Access Compliance Report Public Rights-of-Way (Pedestrian Signals)

Main Street: PROSPECT_ST Cross Street: FAIRHAVEN_AVE Location: NE

ADA ID: SGAT211022104140 Signal Type: One Push Button-Non APS Overall Compliance: No Severity Scores: BTN 1: 35 BTN 2: N/A No BTN: N/A

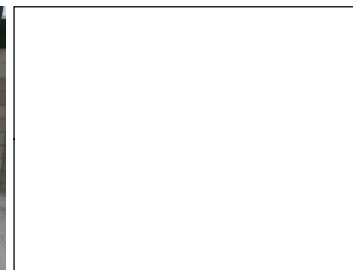
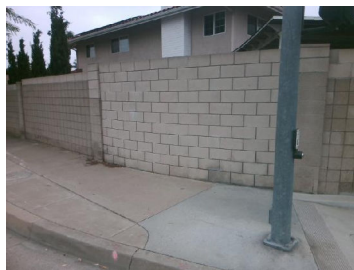
OC Std/PROW: R404.2, R404.3, MUTCD 4e.08

Possible Solutions: Replace Signal Push Button With APS Button. Remove and Replace Clear Space.
